Karara Mining Limited Chute39+99 modification background

CH039 Chute Modification Background

CH099 Chute Modification Background

Figure 3 Site photo

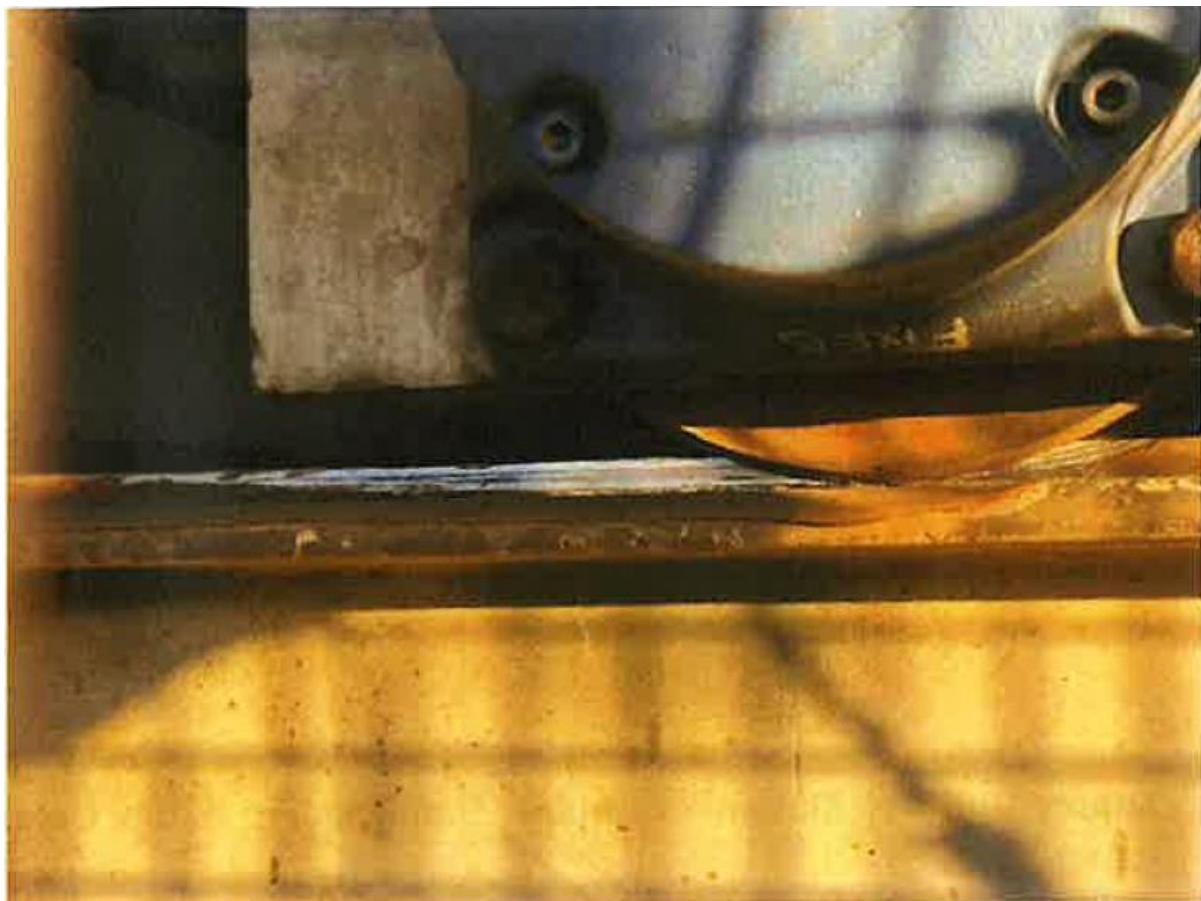
Damage on the CH39 north side rail

To address these ongoing issues and improve overall system reliability, it is proposed to modify the CH039 moving head chute into a fixed central chute. Converting the chute to a fixed configuration will eliminate the uneven loading from the hydraulic system, reduce maintenance frequency, and provide a long-term, stable solution for the current reliability problems.
